Design Response Conference 10/19/2009

Building A Articulation

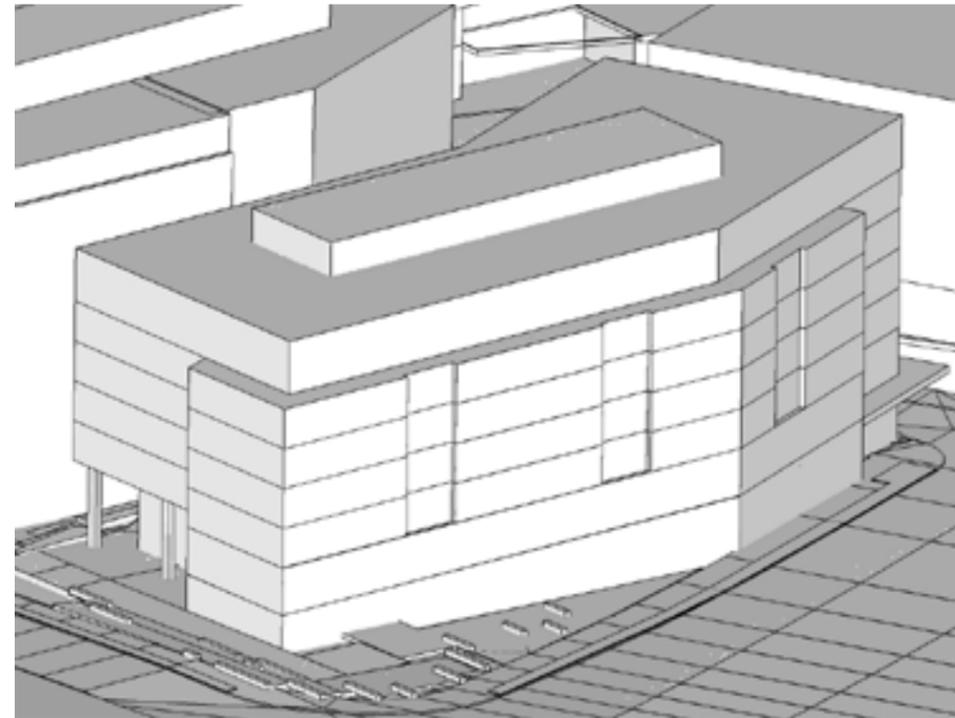
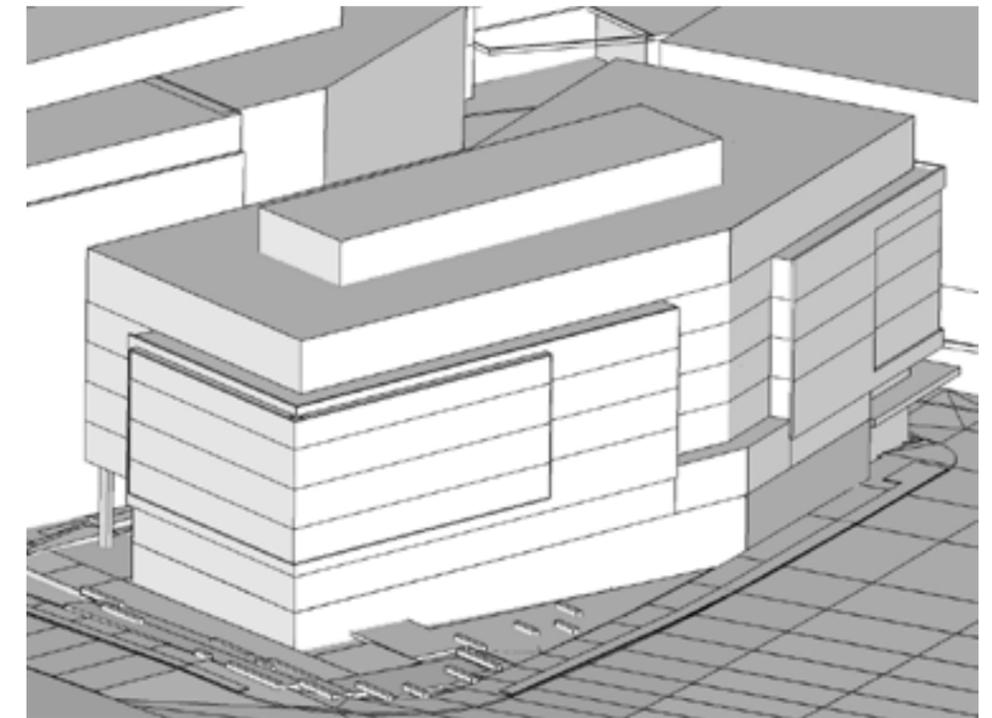
DRB comment: Create visual interest along the street.

Response: It is our intent to create a rich visual environment for pedestrians. Further information that describes this will be shown as Building A develops.

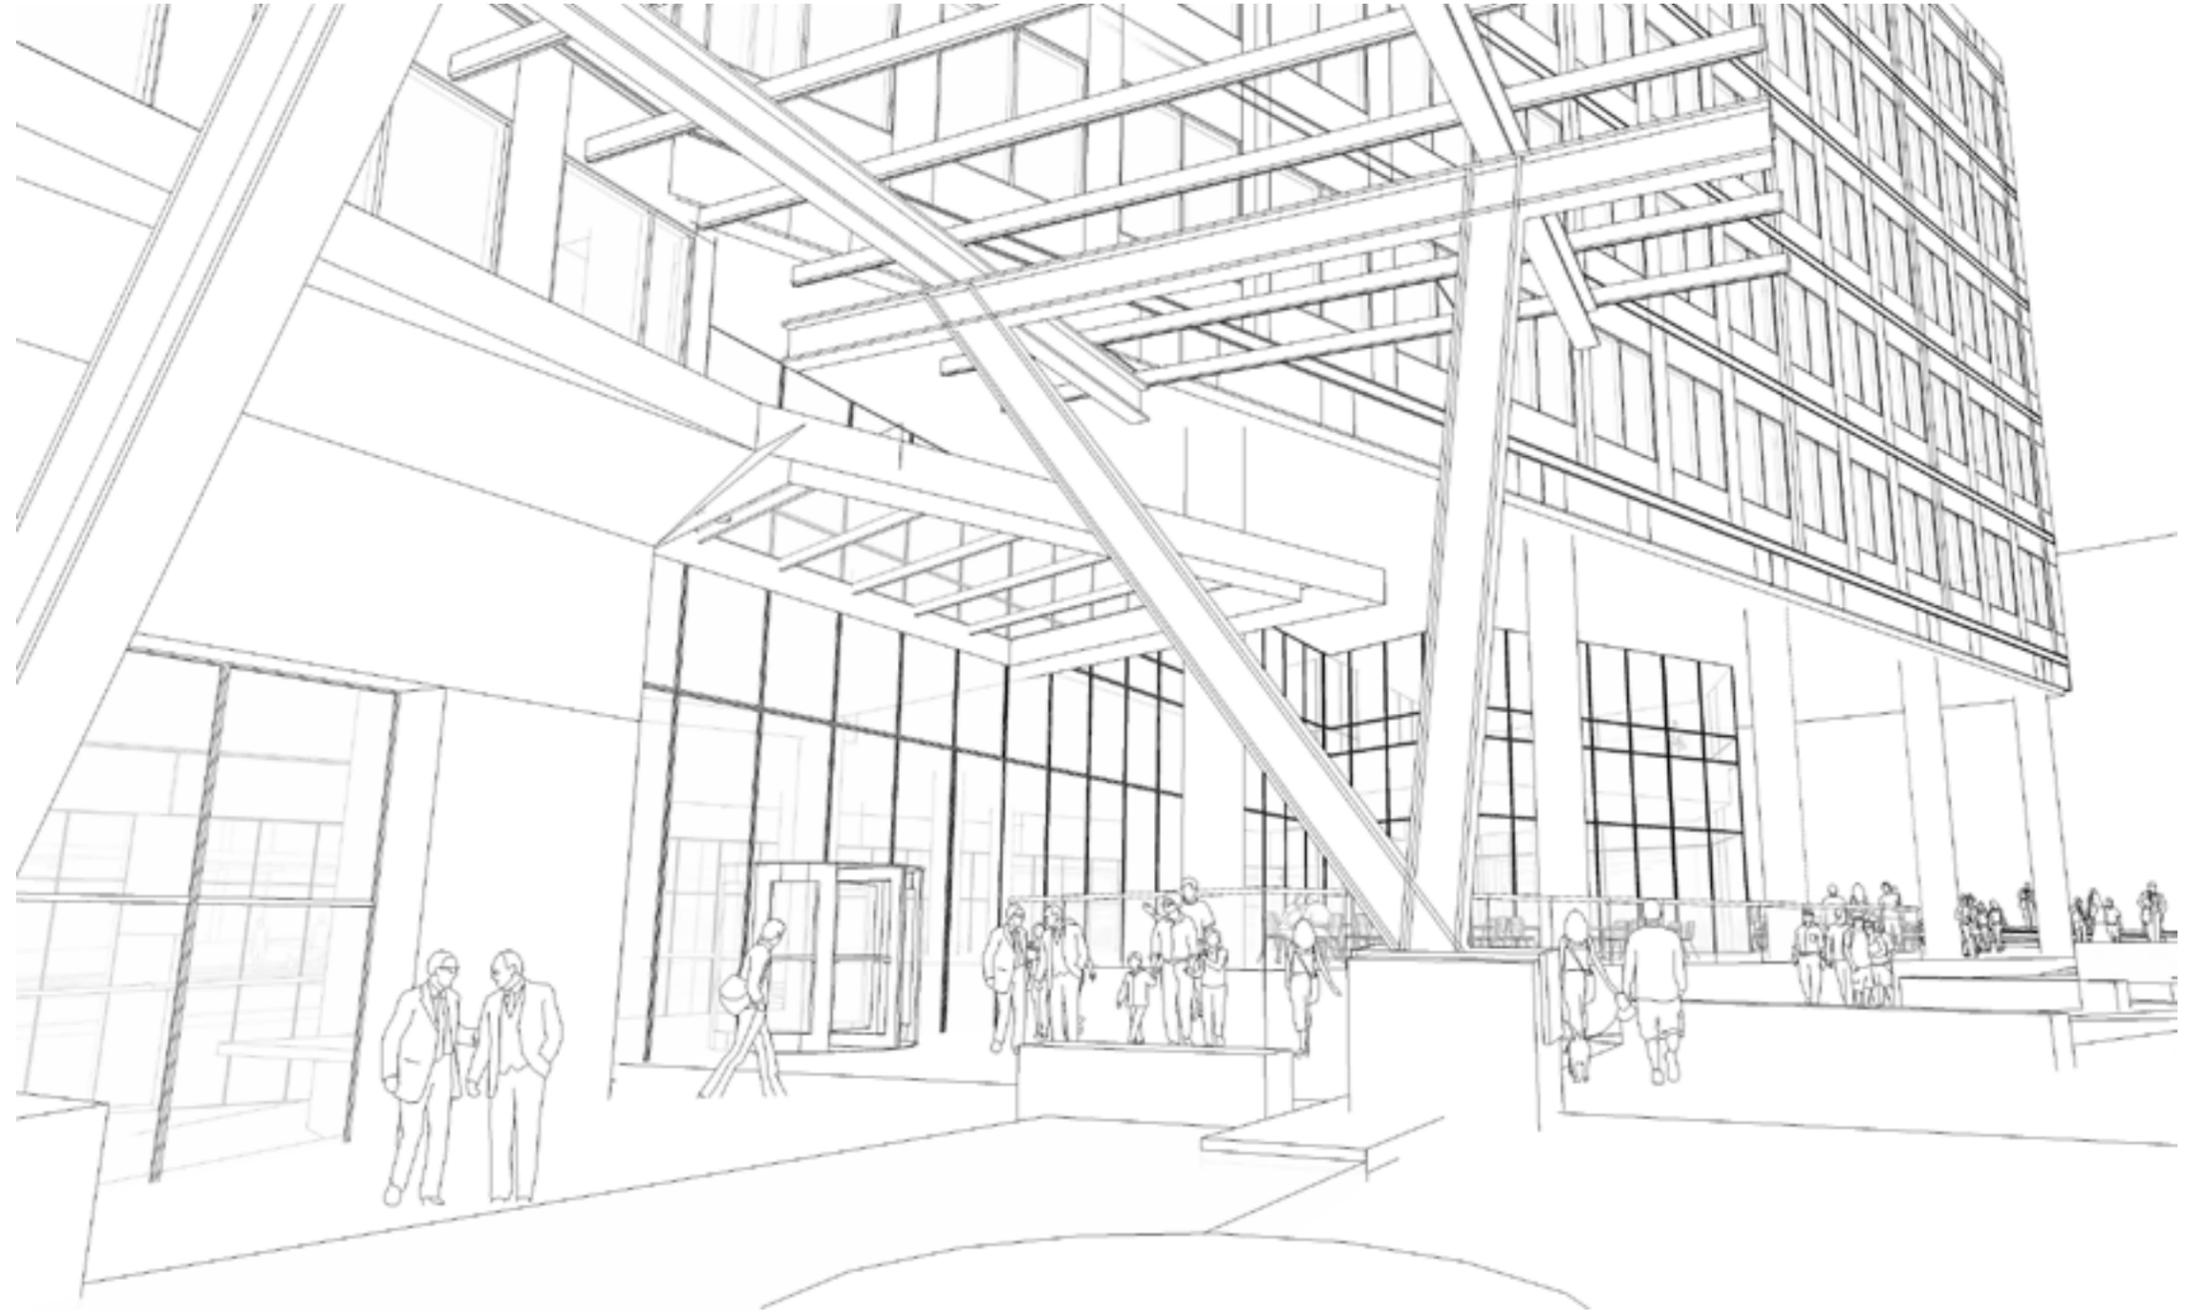
DRB comments: **BIG PICTURE:** What's important? Order & scale, base, roof edge.
 f. Be careful windows don't look like ribbon windows.
 g. Use major architectural expressions for important gateways & intersections. Buildings B & C need more of this. Where is the entrance to Building A??

Response: We have avoided the use of ribbon windows throughout the design. The massing and articulation of the buildings emphasize key entries to the site as prescribed in the Design Guidelines. Building A's entrance is off the pedestrian street on the south side, opposite Building B's entrance. The termination of the gasket signifies entry into Building A and sets a precedent for future building design.

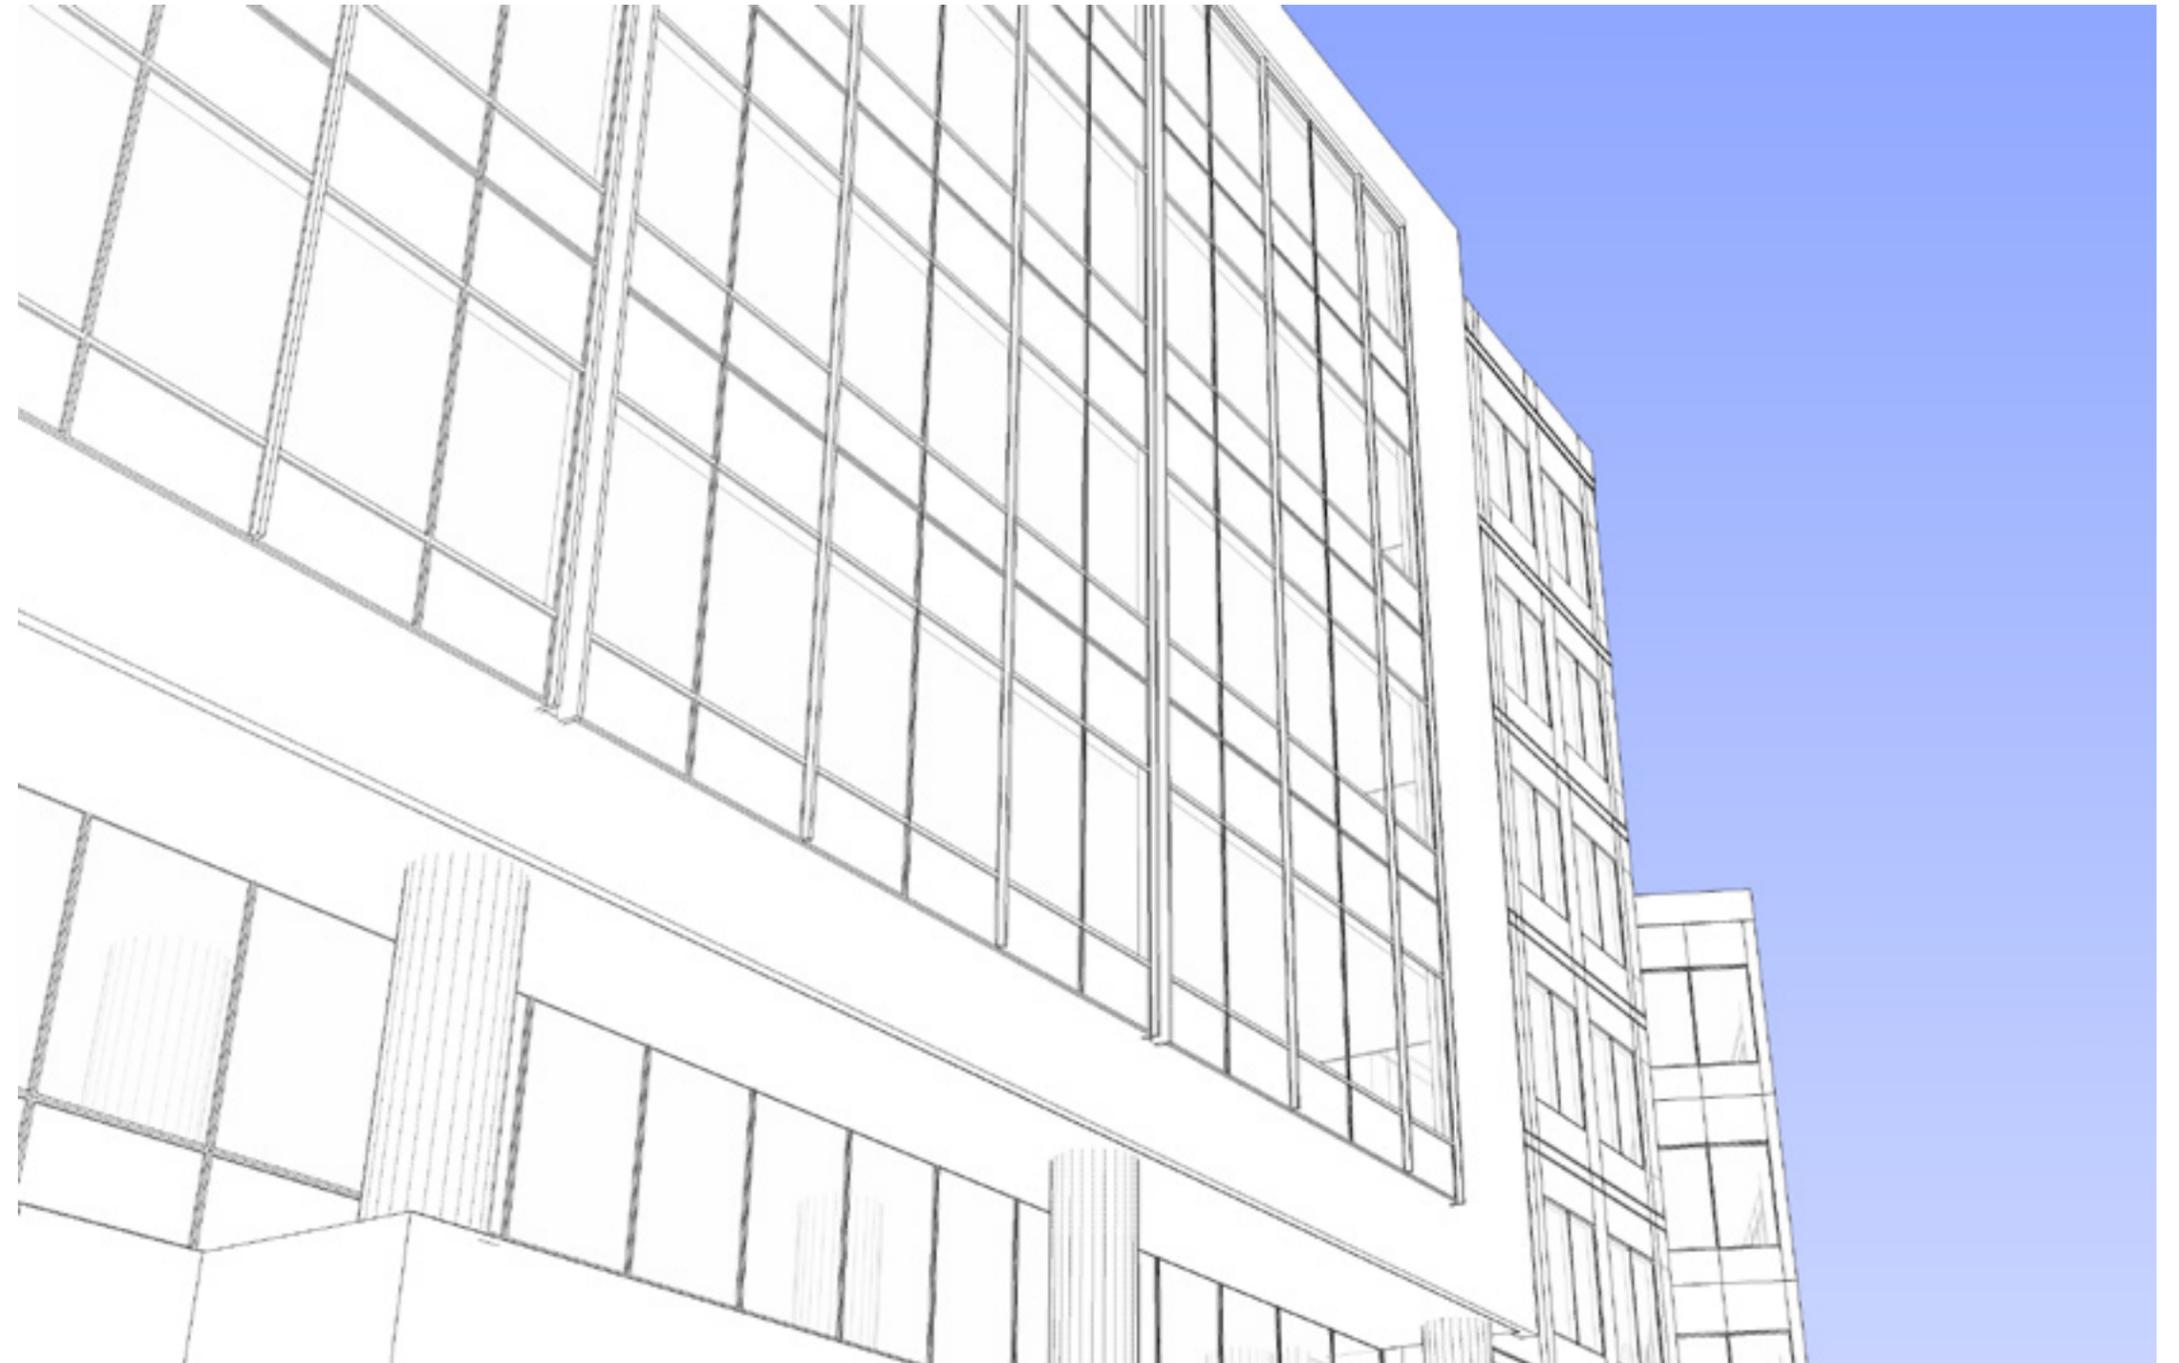
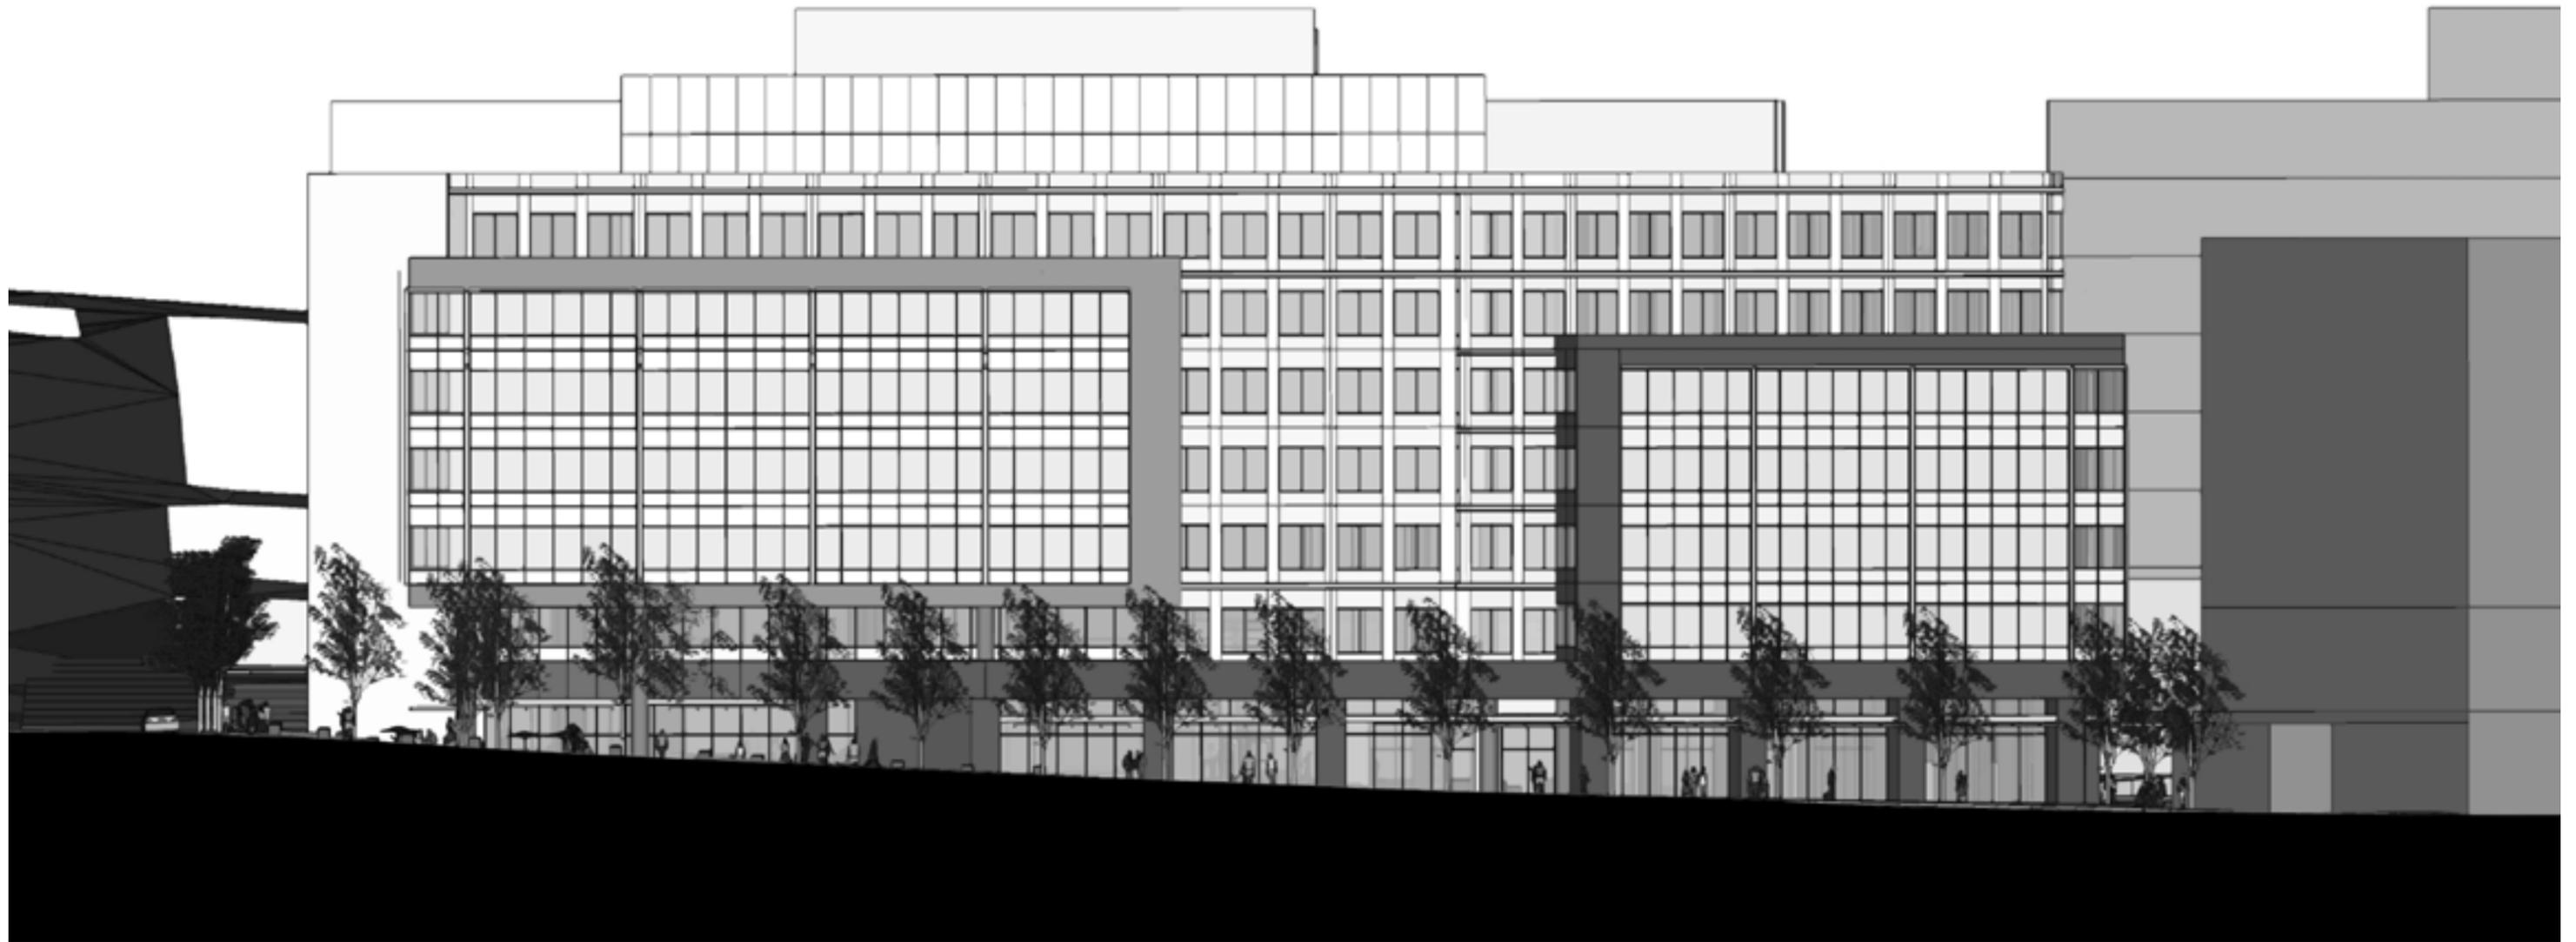
DRB comments: h. Building modulation: same discussion as e above (e. Provide clear pattern of building openings. Windows, balconies and bays should unify a building's street wall and add considerably to a façade's three-dimensional quality.).

i. Roof Silhouettes – Scale & massing comes first and then roof solution will follow.

Response: The strong articulation of the horizontal modulation on the revised Building A design will be visible against the sky from the street level, enlivening the building's profile consistent with the intent of the Design Guidelines.
